Planning Commission Staff Report

Kidztown Daycare at Corner of Lynne Road and Highway 89
(Lot 6 Willow Brook Village Subdivision) - Site Plan
Application
May 4, 2023

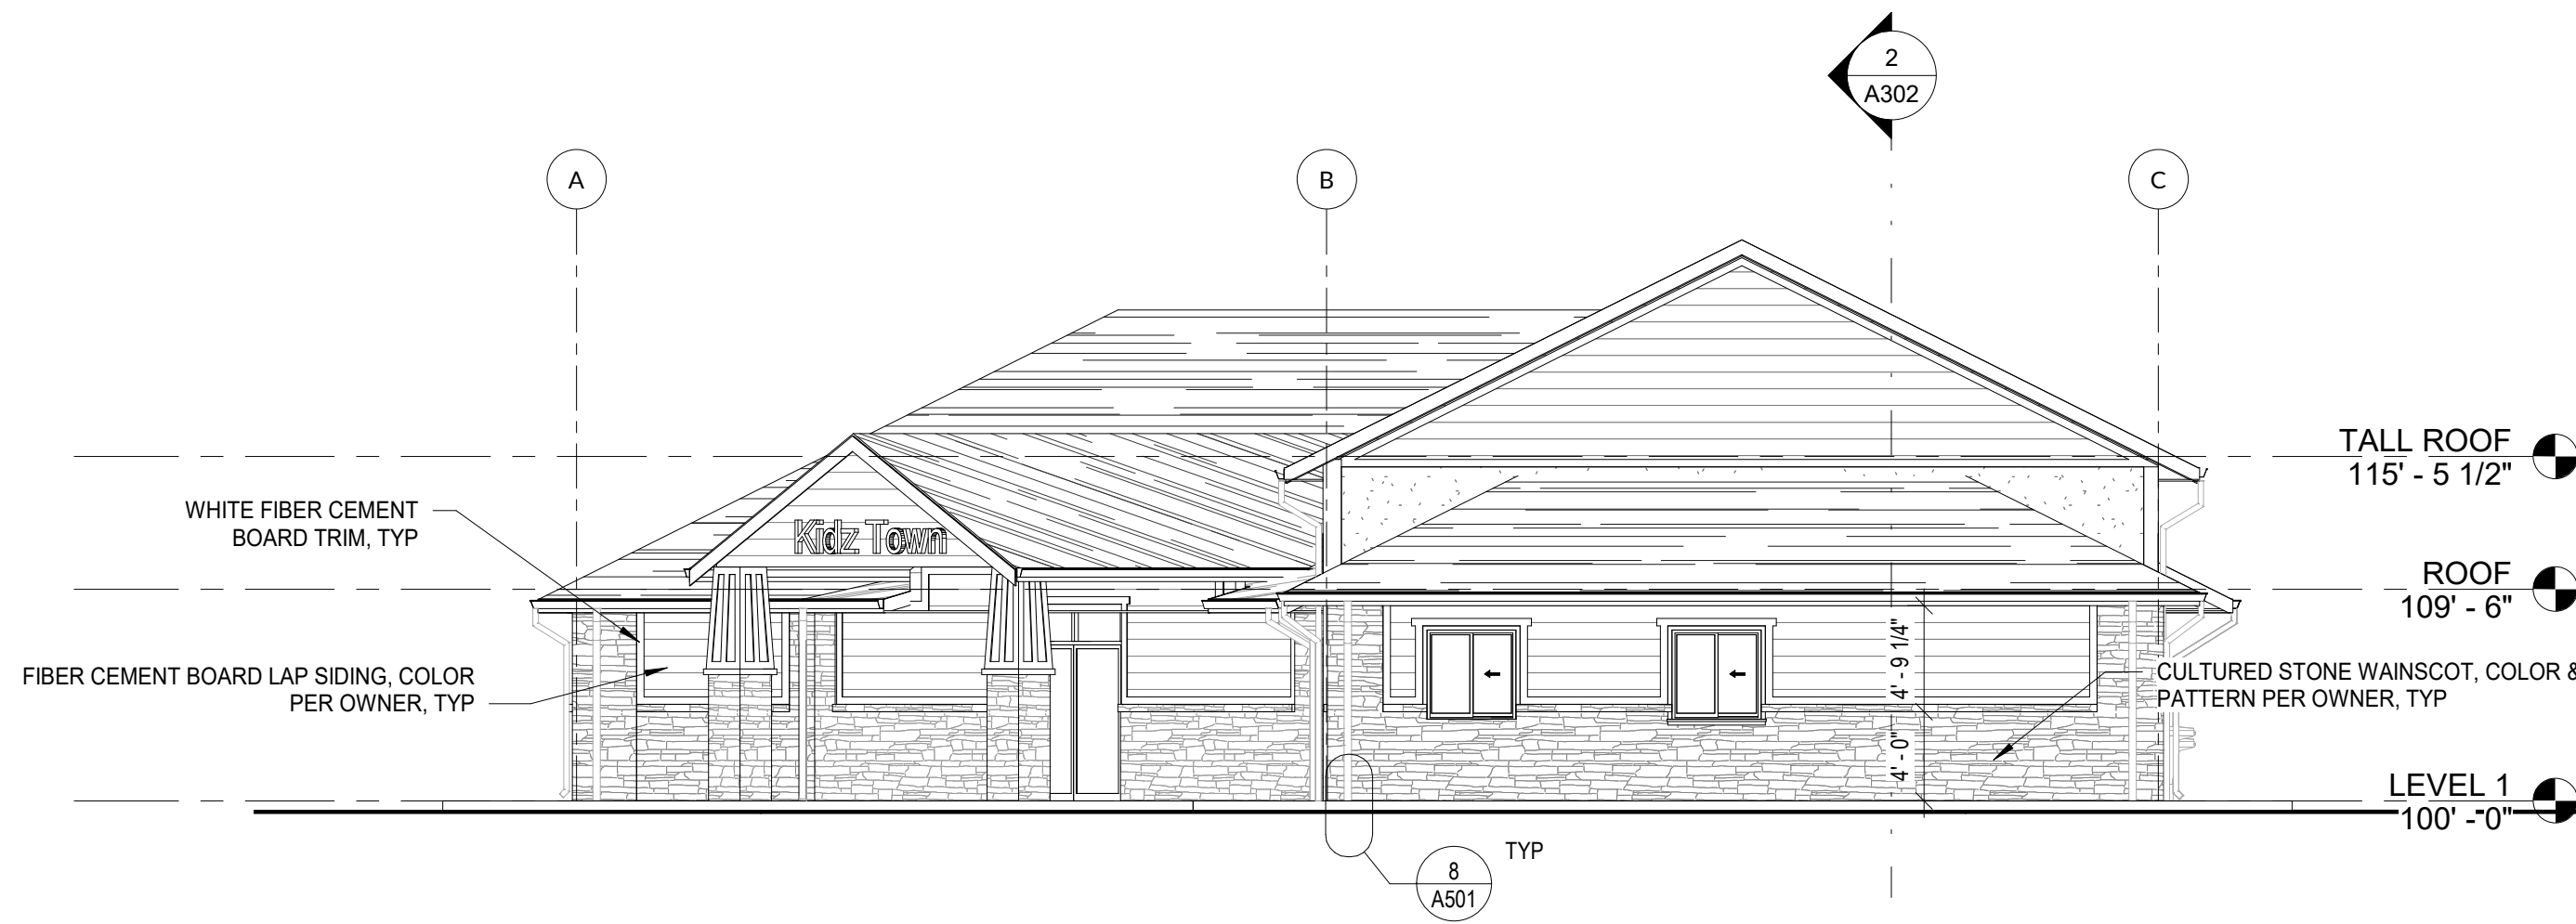
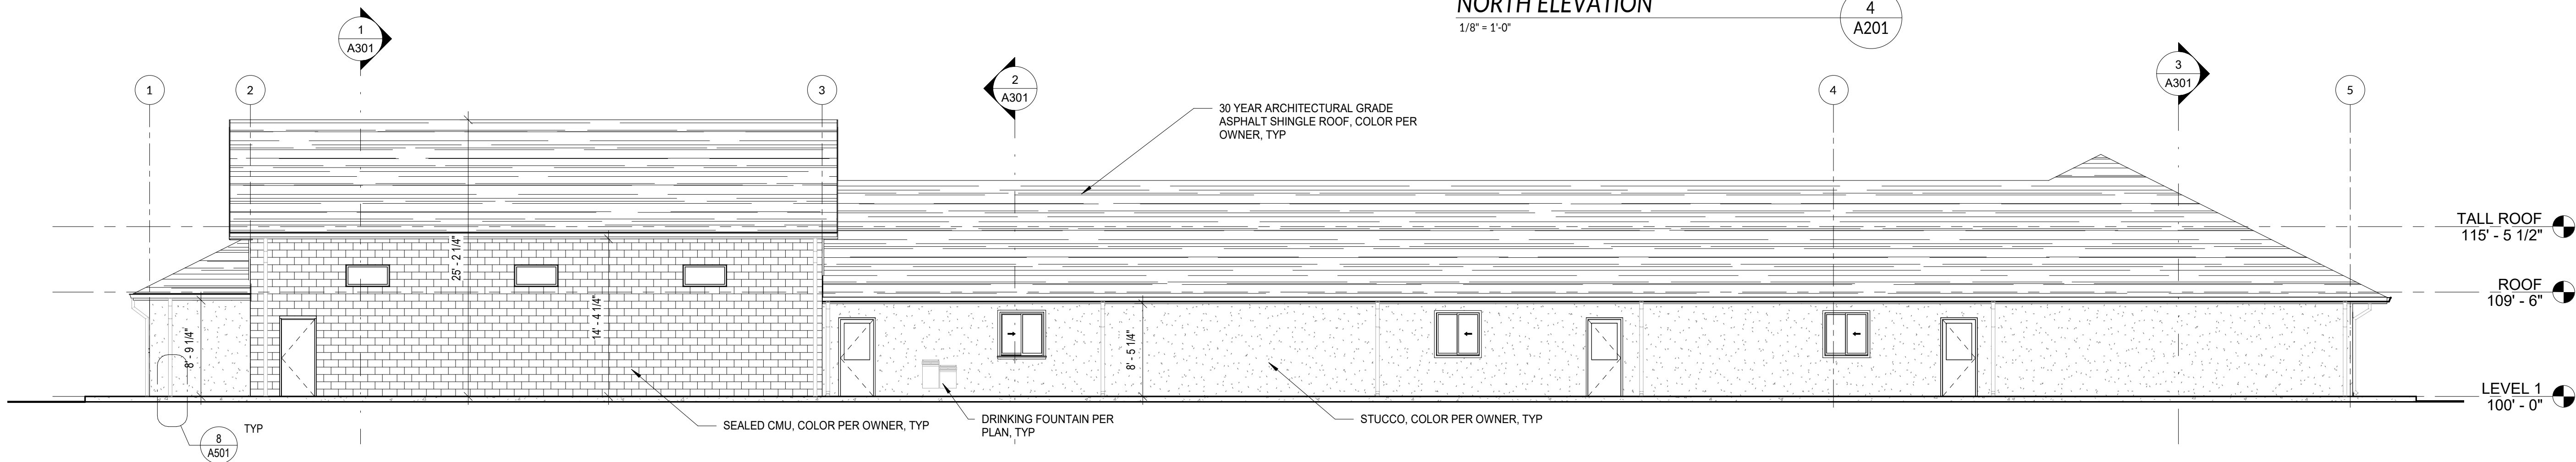
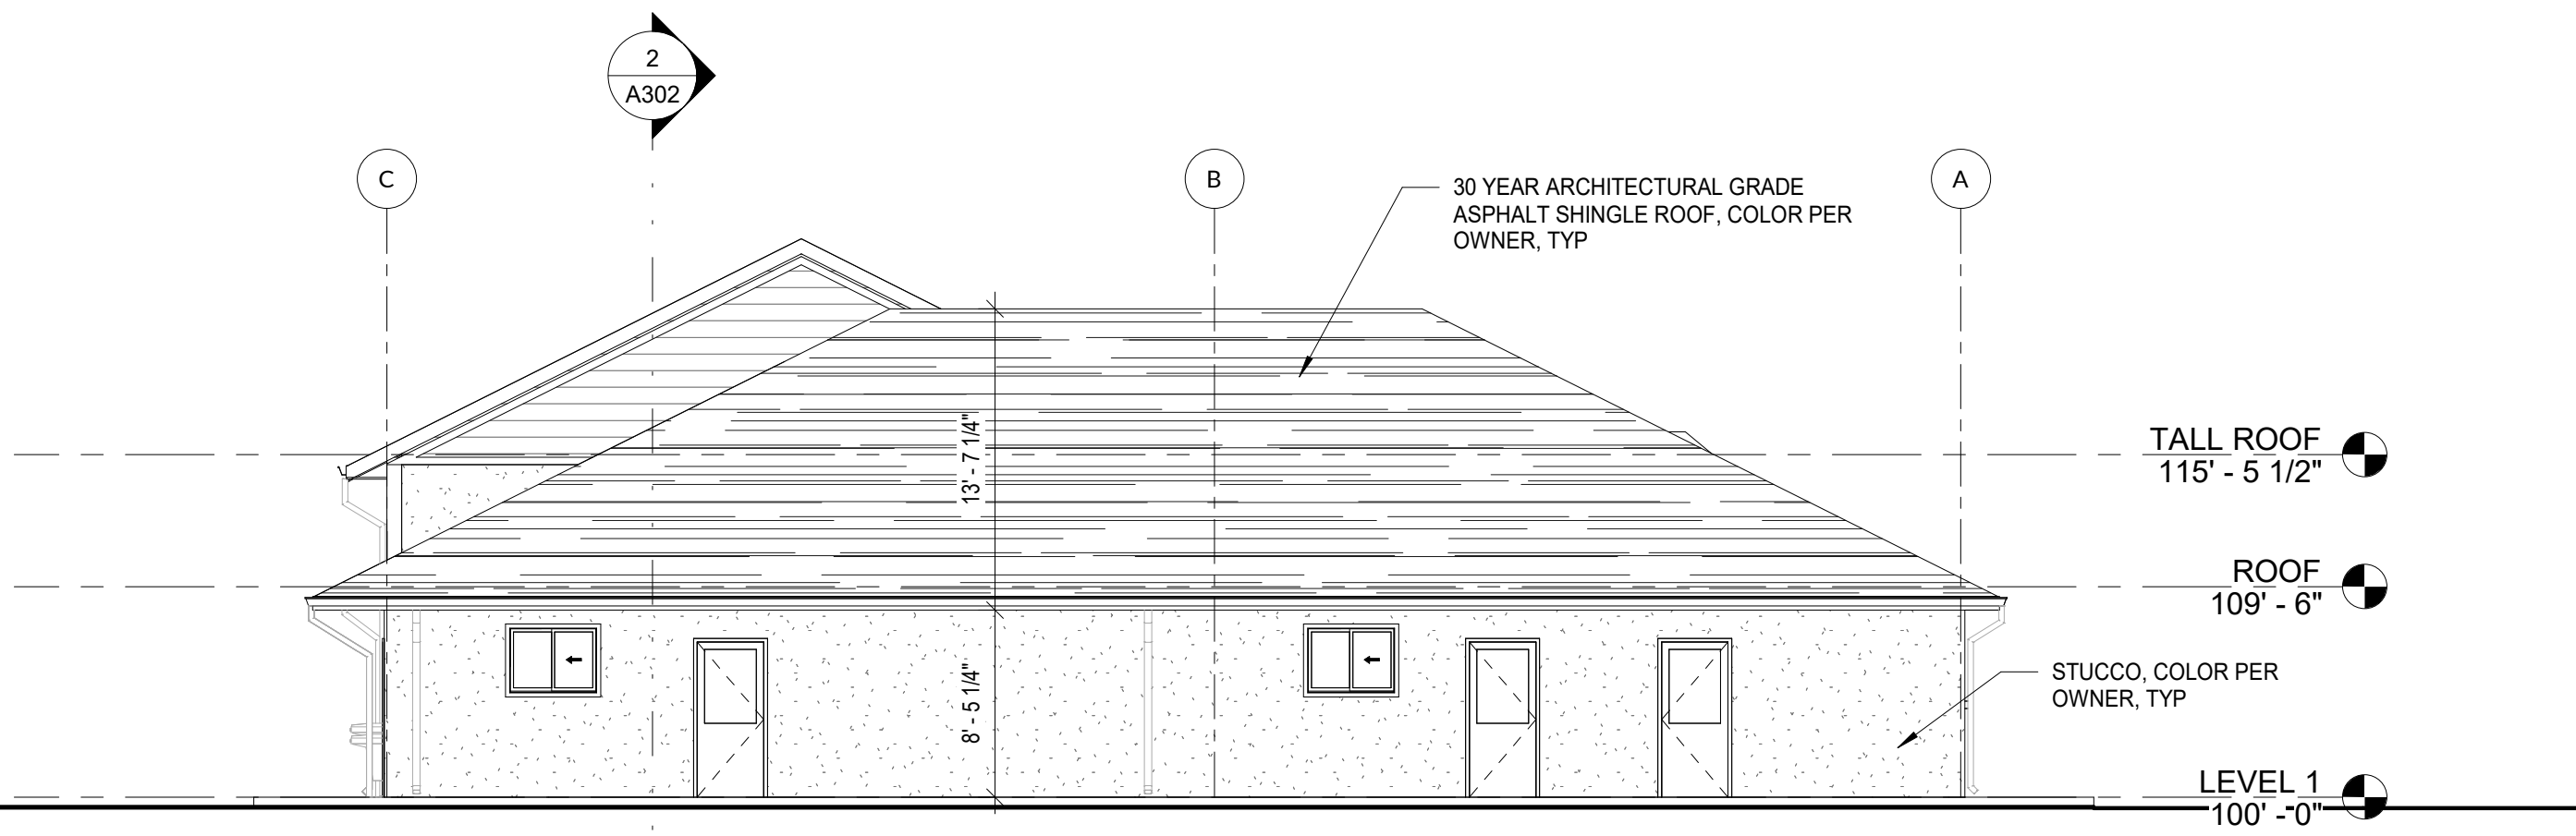
Staff Comment: The building height is less than 26 feet (approximately 25' 8 ¼"), and meets the height limit. (See Exhibit B).

Exhibit C - Kidz Town - Landscape Plan

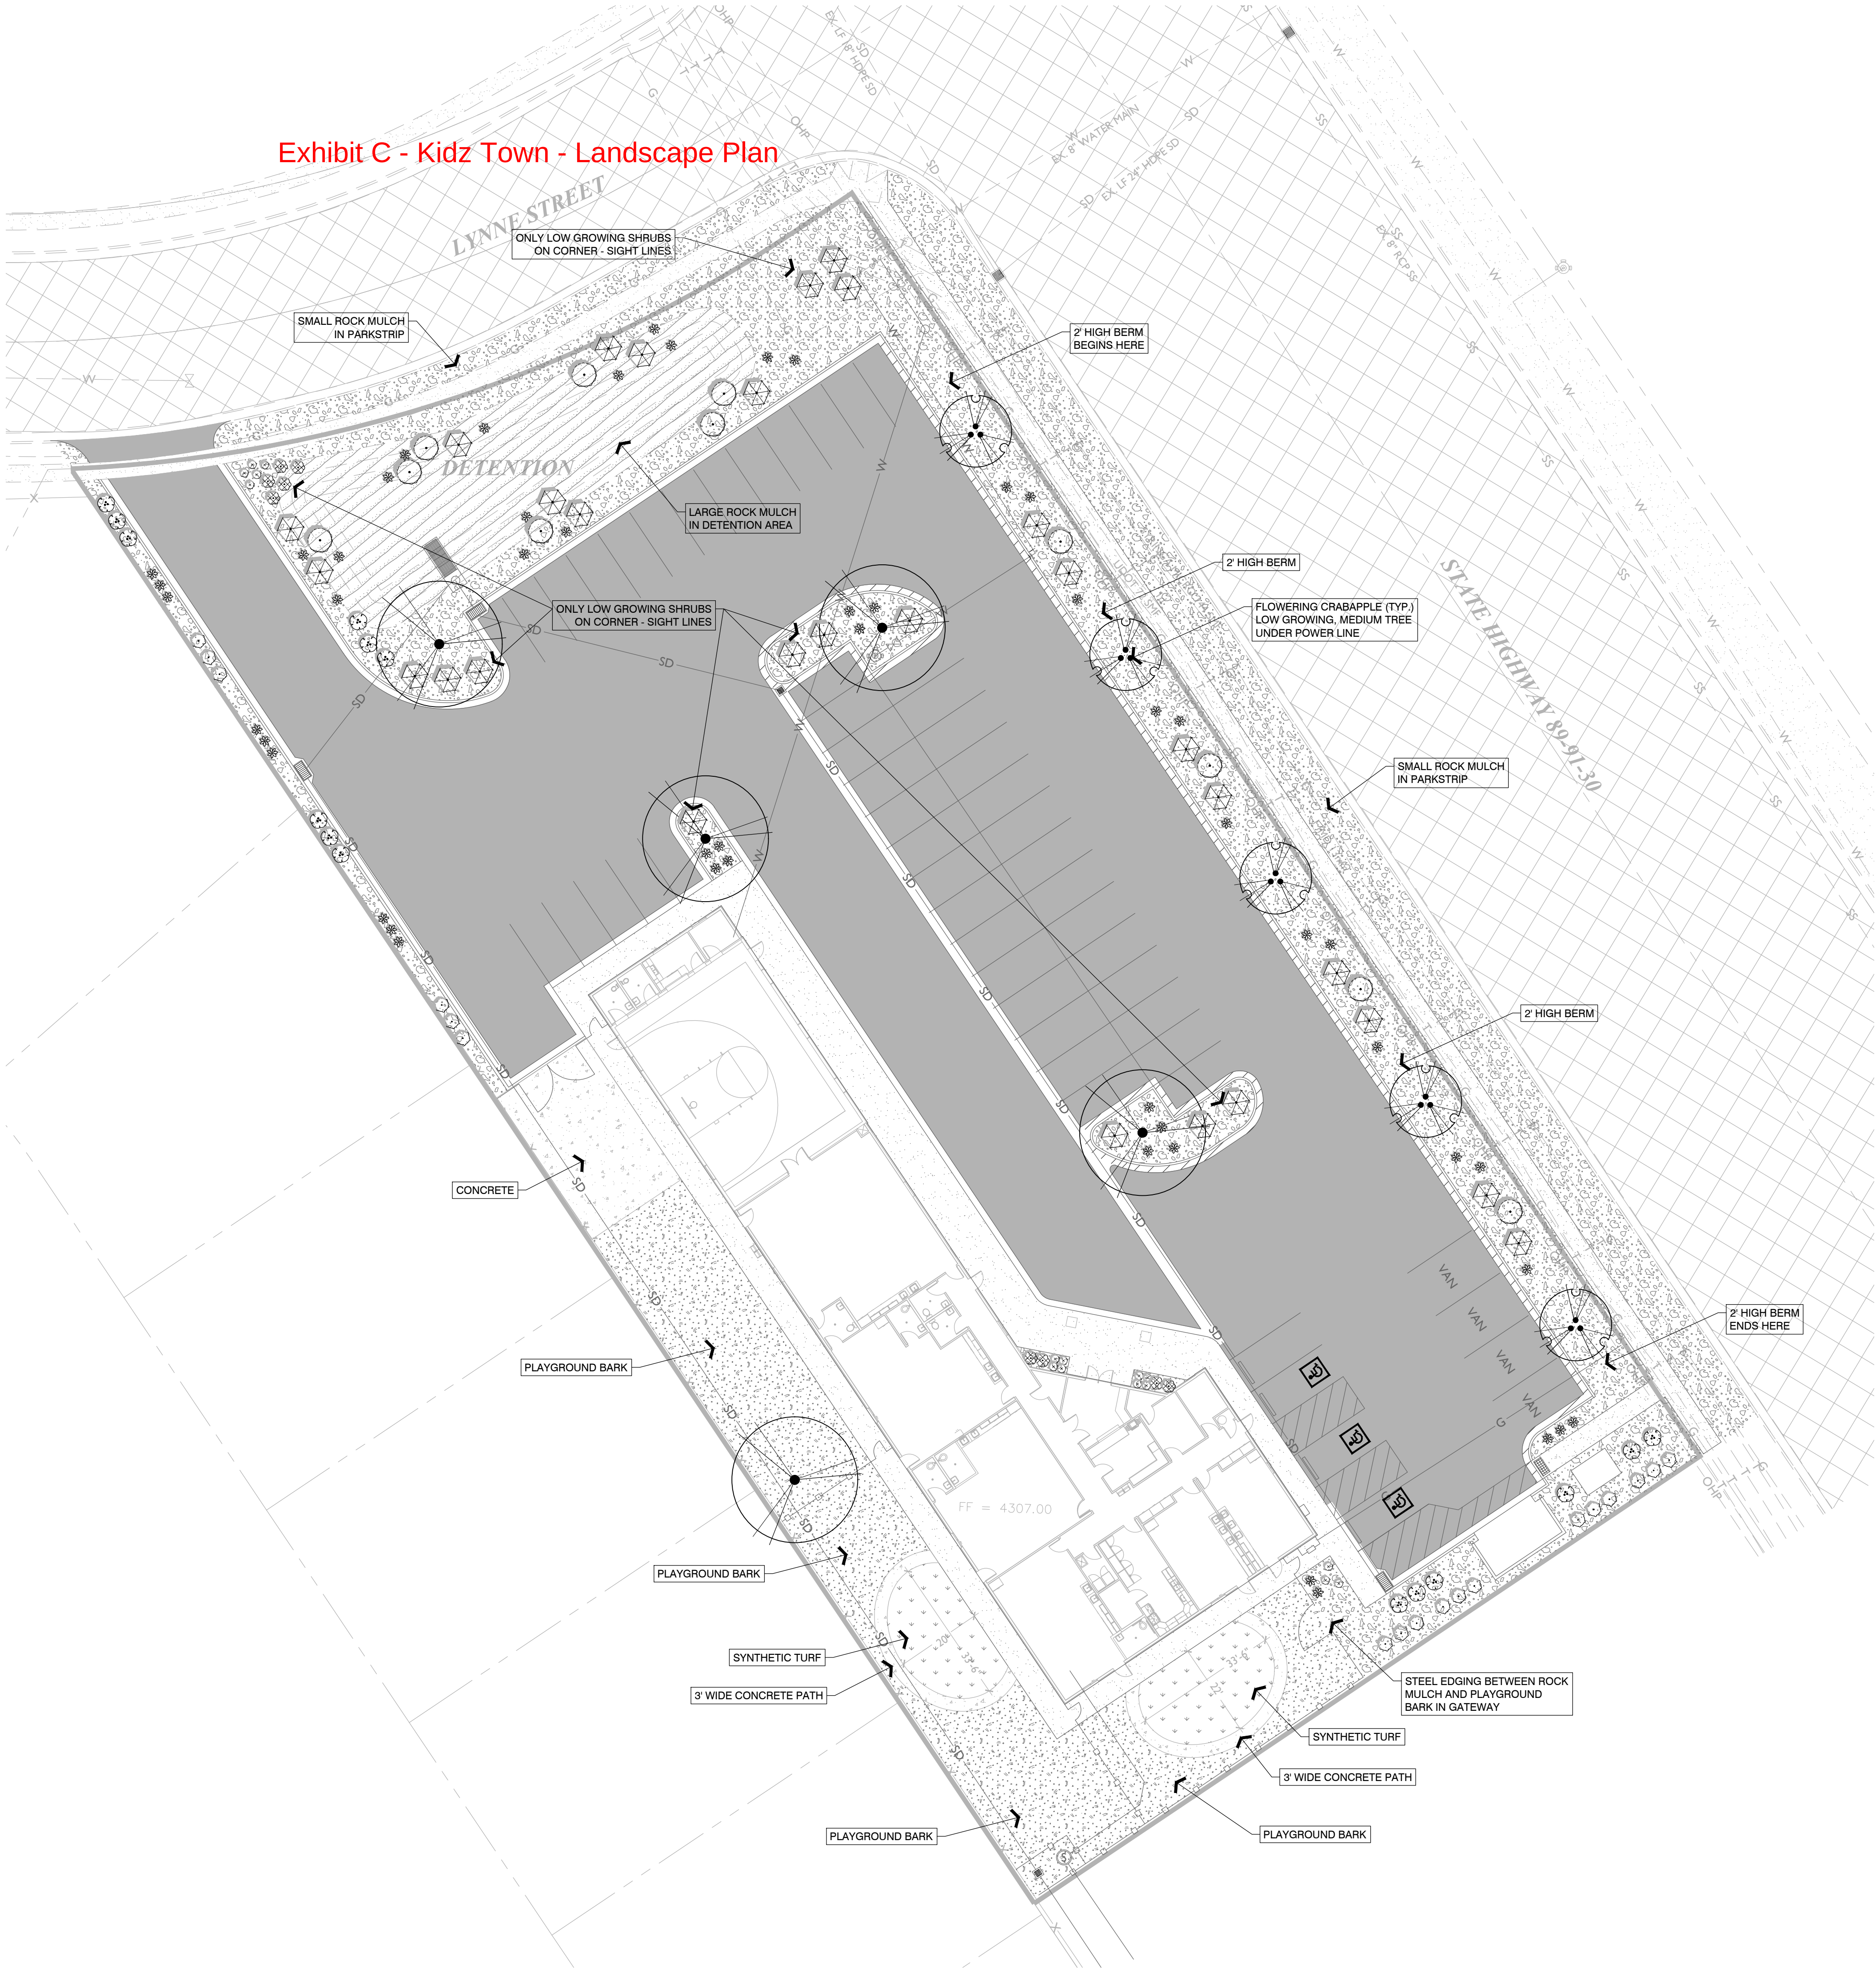
Finally, the applicant has provided a detailed, attractive, and thorough landscape plan, including trees and xeriscape plantings (See Exhibit C).
